WORKSHOP AGENDA

Planning Commission

Item Title: Preliminary Plat - Blair Ridge - One (1) Lot on 15.80 Acres. Requested by SEC, Inc. Property located on Blair Road (Tax Map 29, Parcel 21.01). R-3 (High Density Residential) Zoning District. Property owned by 303B Partners.

Item Title: Site Plan - Blair Ridge - 141 Dwelling Units in 26 Buildings. Requested by SEC, Inc. Property located on Blair Road (Tax Map 29, Parcel 21.01). R-3 (High Density Residential) Zoning District. Property owned by 303B Partners.

Proposed Site Plan
C-2.0

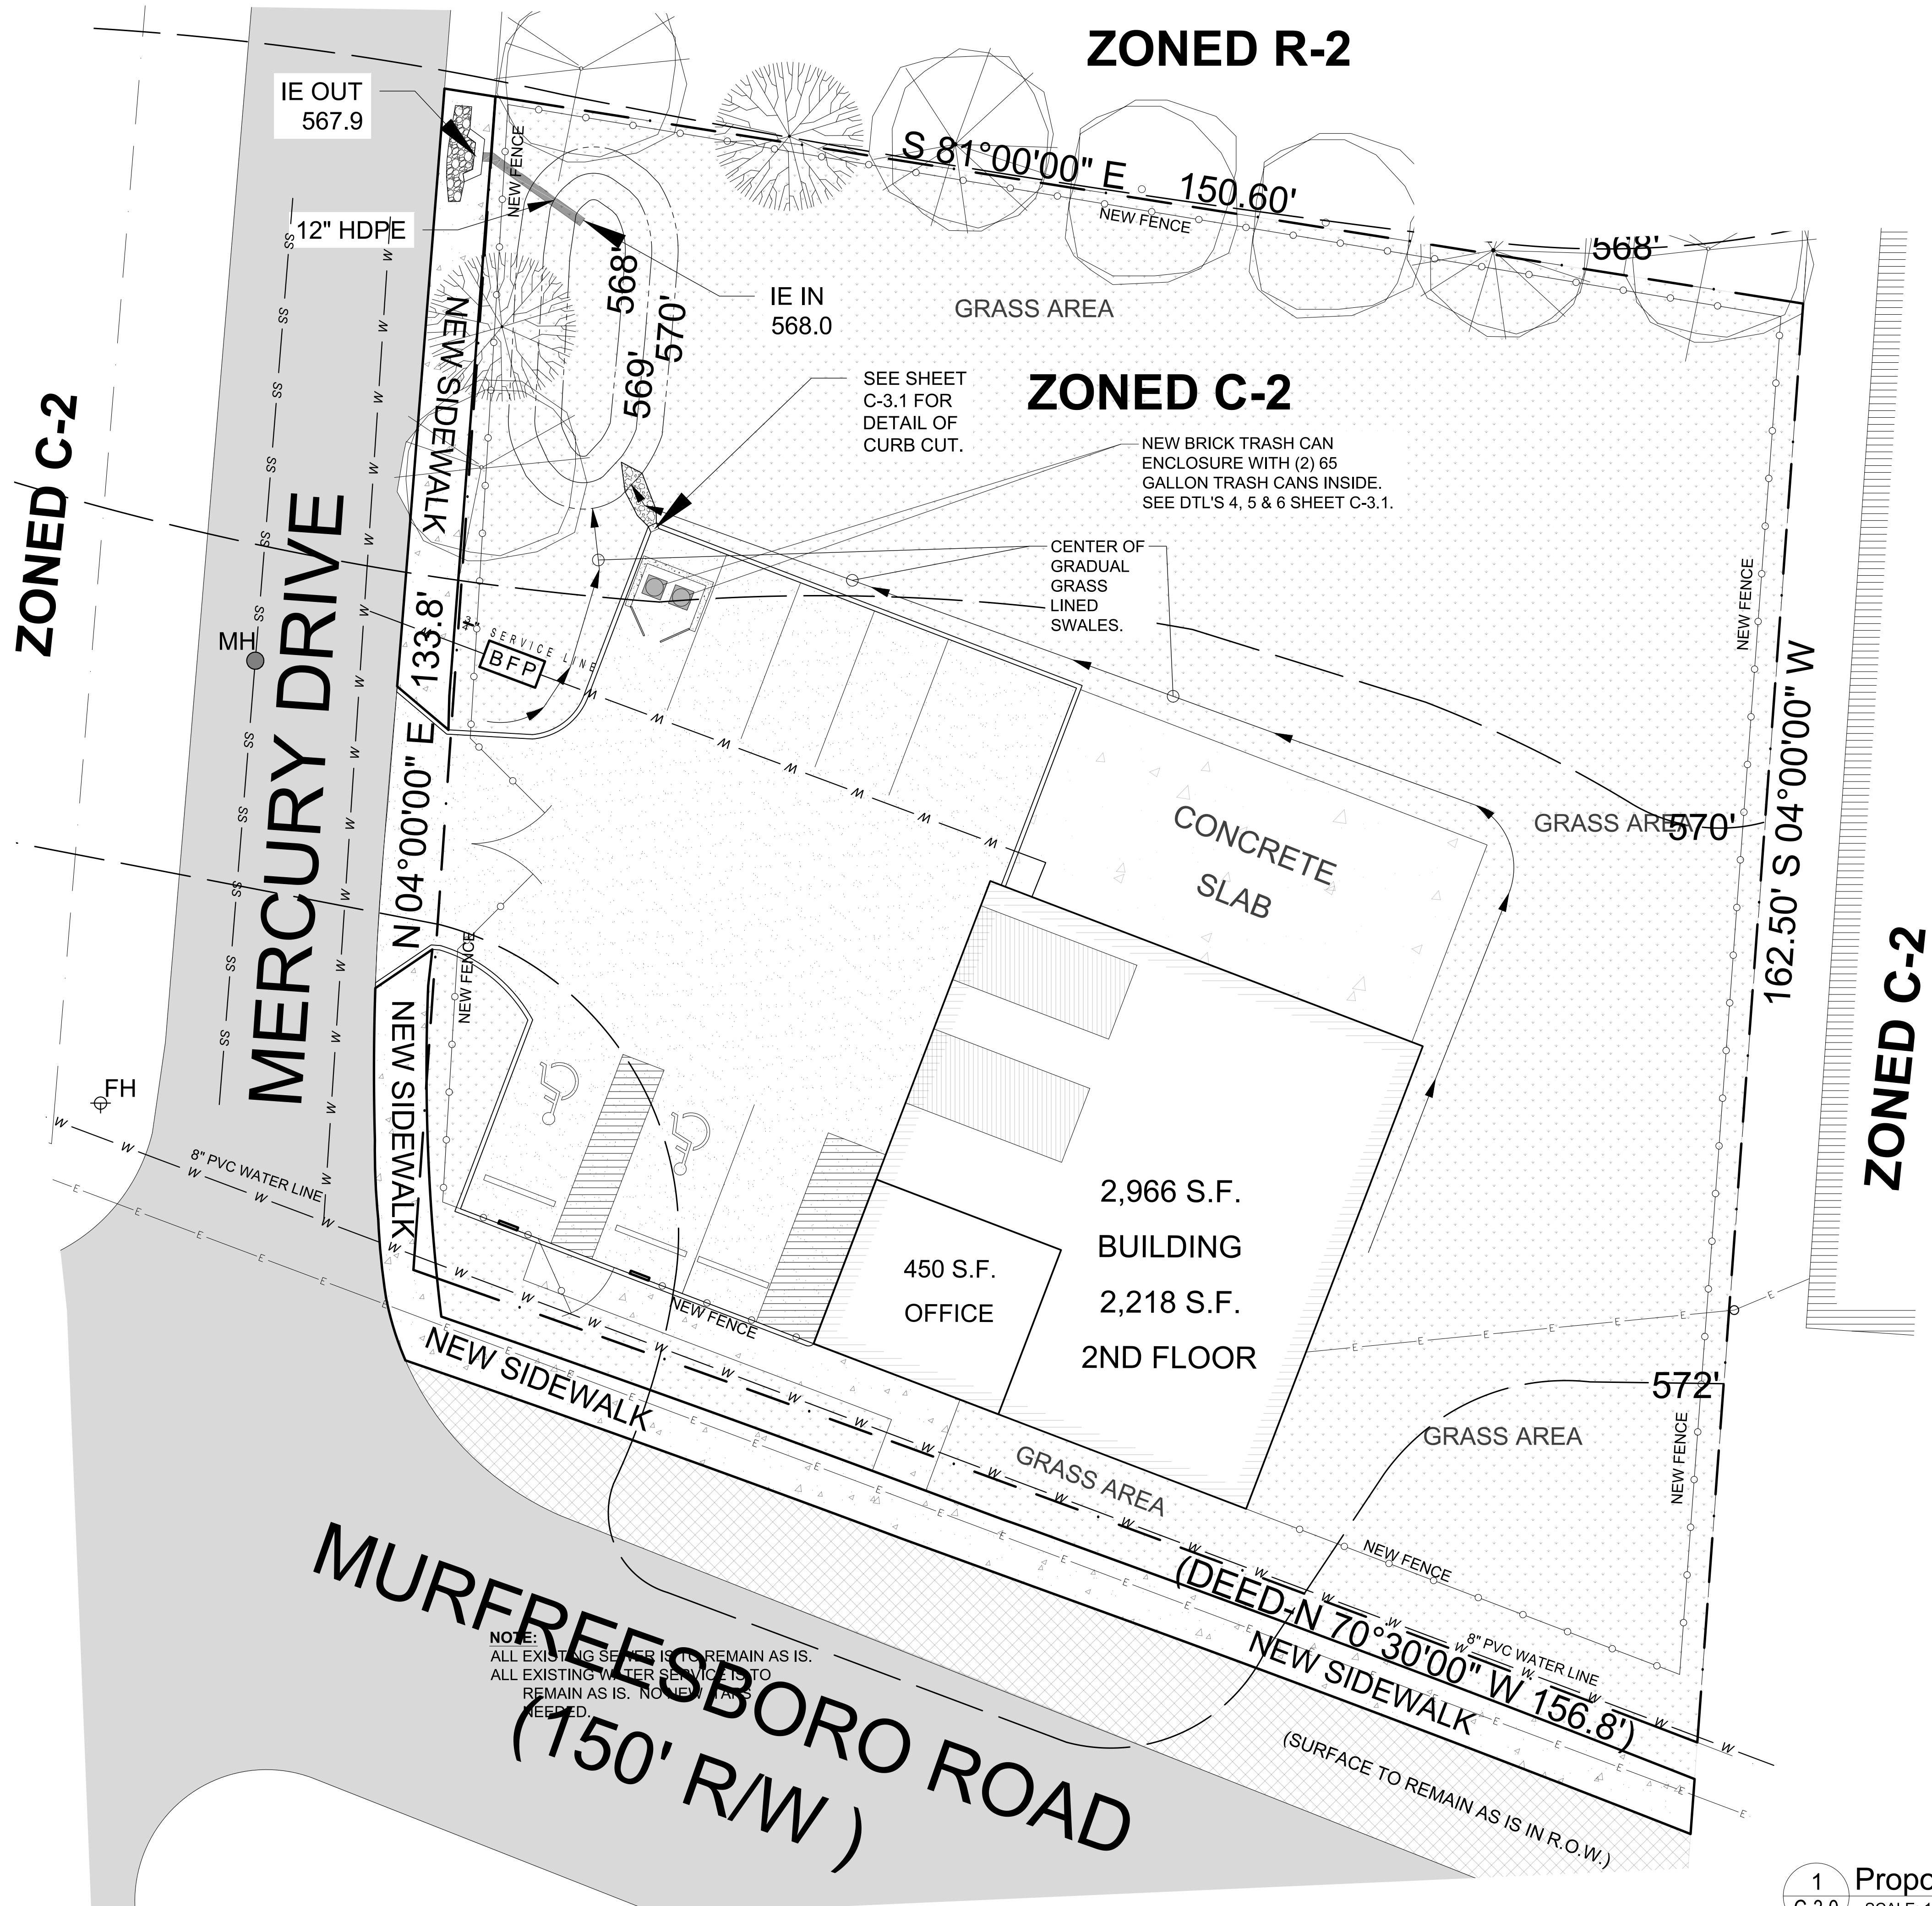
2. (Sheet C-2.0) Show and dimension the proposed architectural addition which is intended to be shown on sheets A-1.0 and A-1.1.
3. (Sheet C-2.0) Parking space #1 does not match what was already built. Please revise drawing to match what is intended.

4. (Sheet C-1.0 or C-2.0) Show dimensions of concrete slab on the north side of the building.
5. (C-3.0) Provide spot elevation at curb cut into detention basin.

1 Proposed Grading Plan
C-3.0 SCALE: 1" = 10'

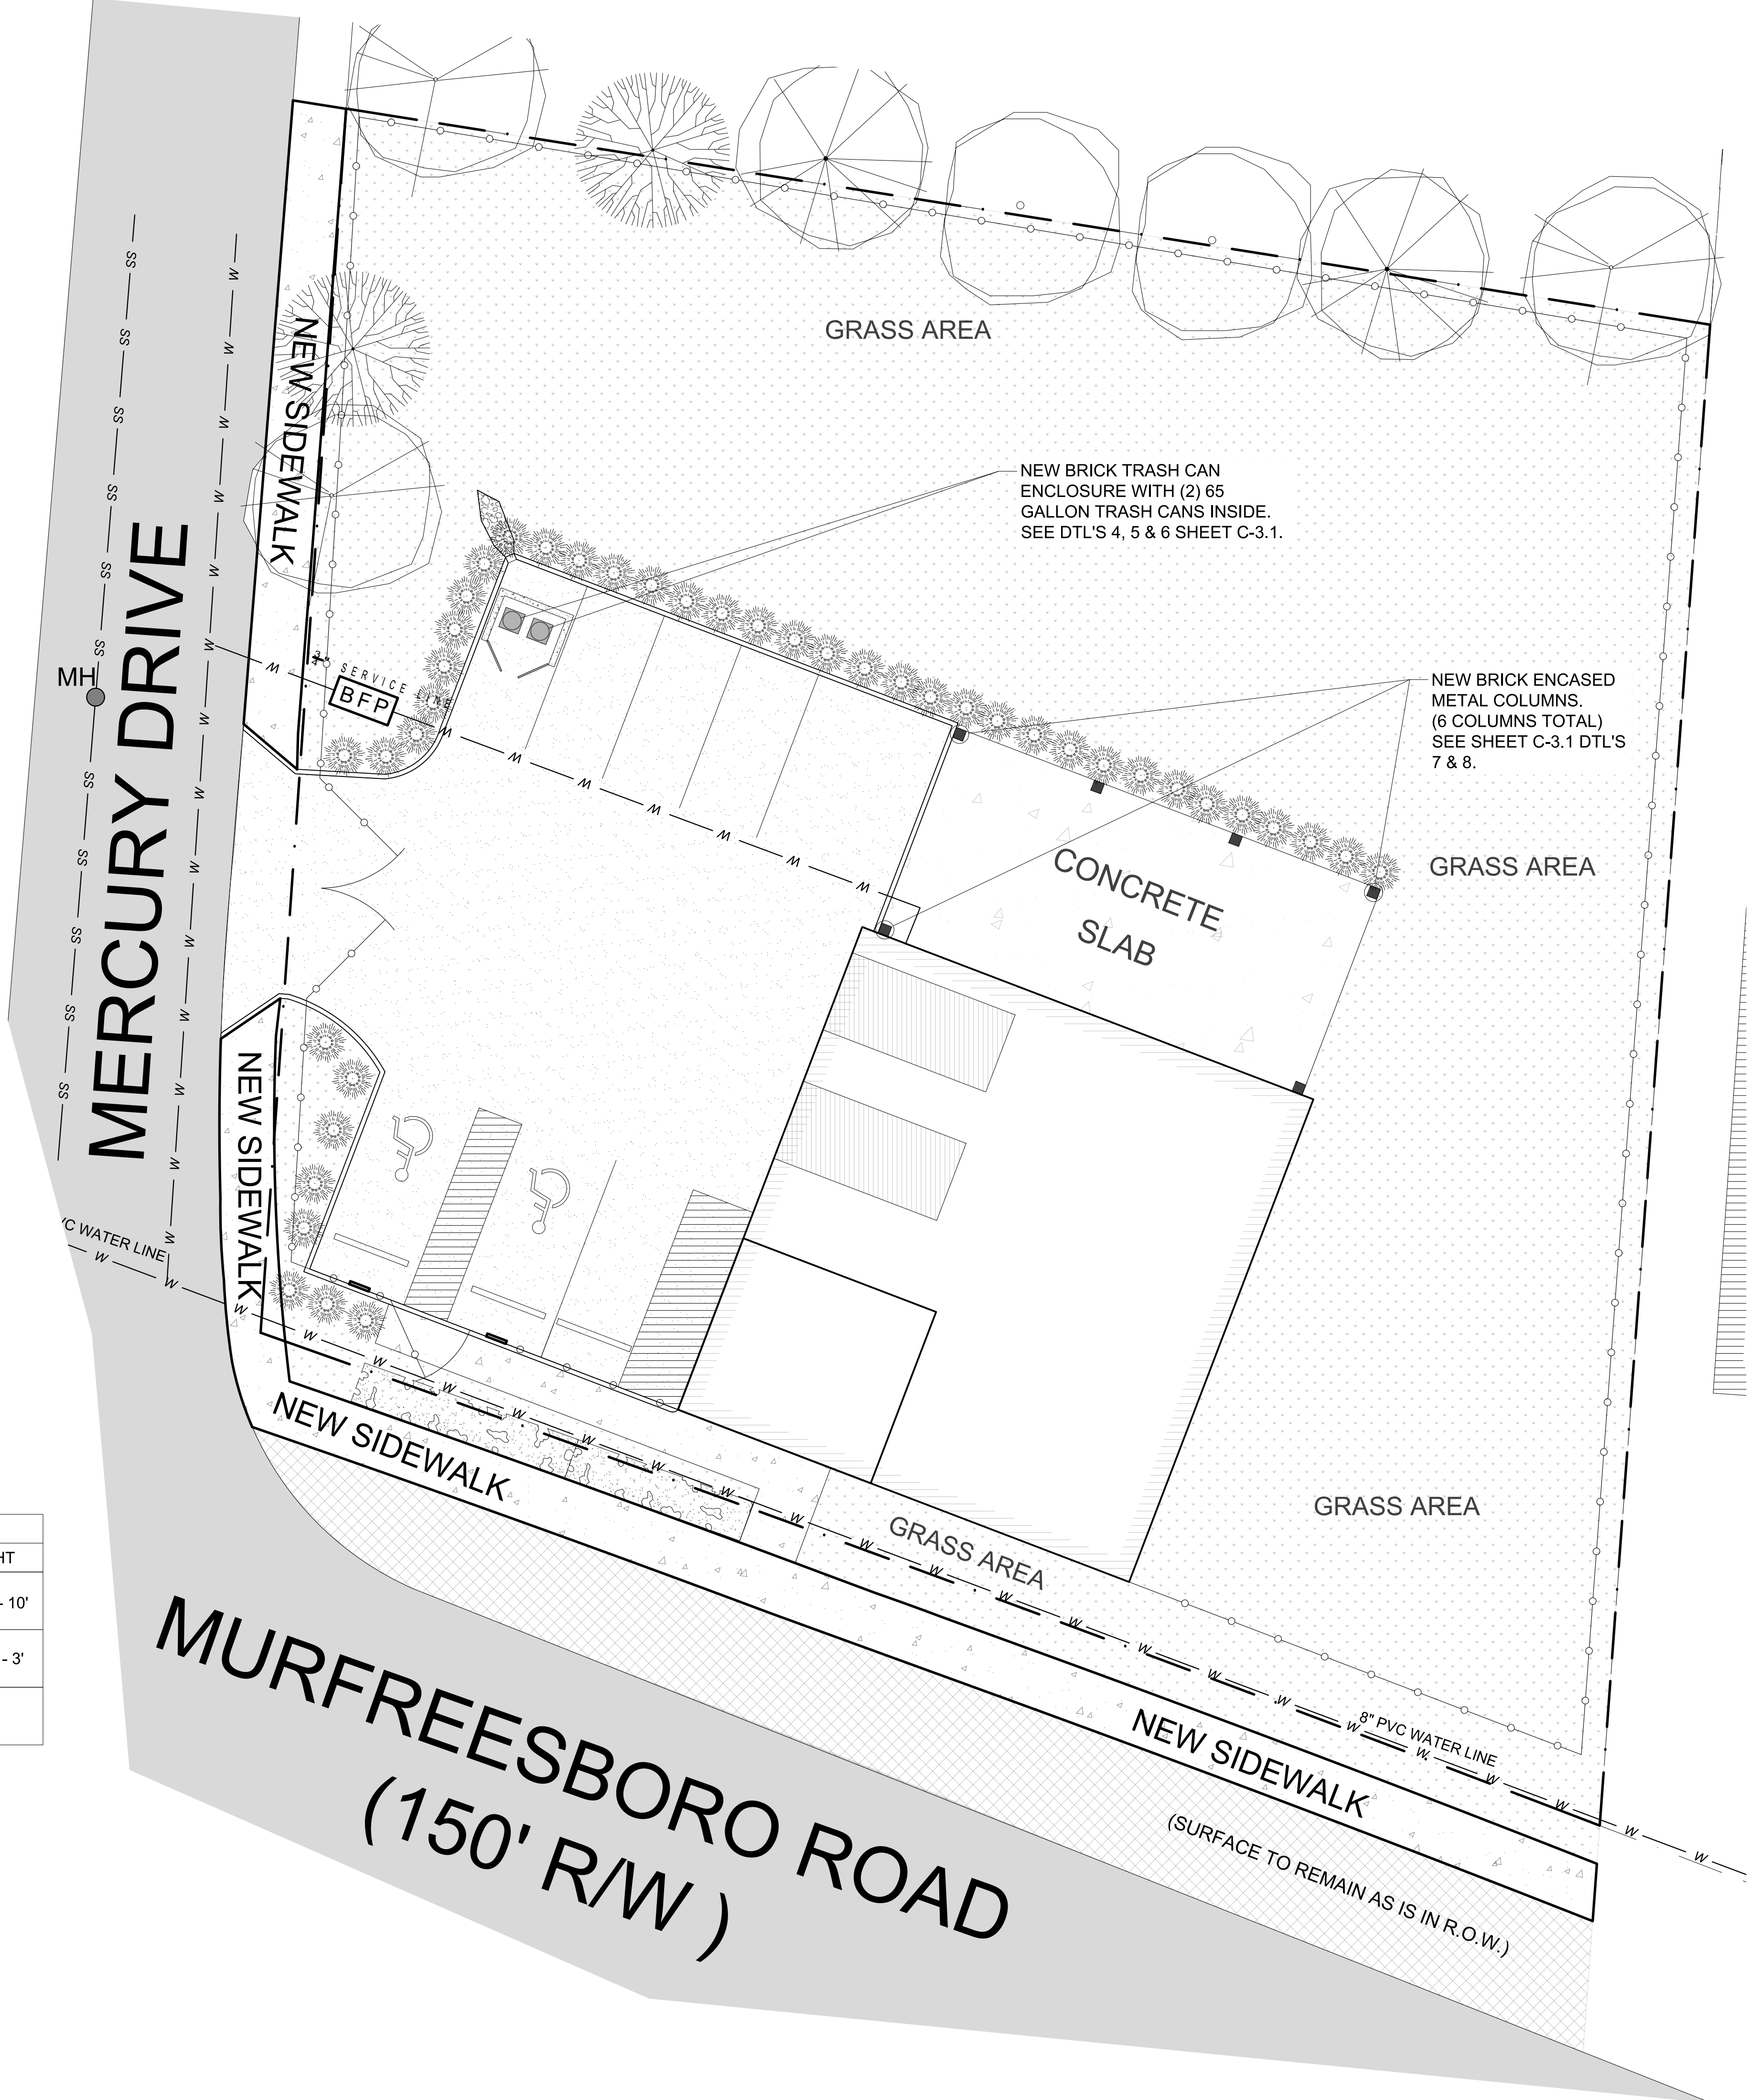
6. (C-3.0) Provide spot elevations along swale to confirm drainage slope.
7. (C-3.0) It is assumed that some work will be needed to rework the swale and direct all drainage into the detention basin per the original design. Provide erosion and sediment control and rename this sheet "Proposed Grading and EPSC Plan".
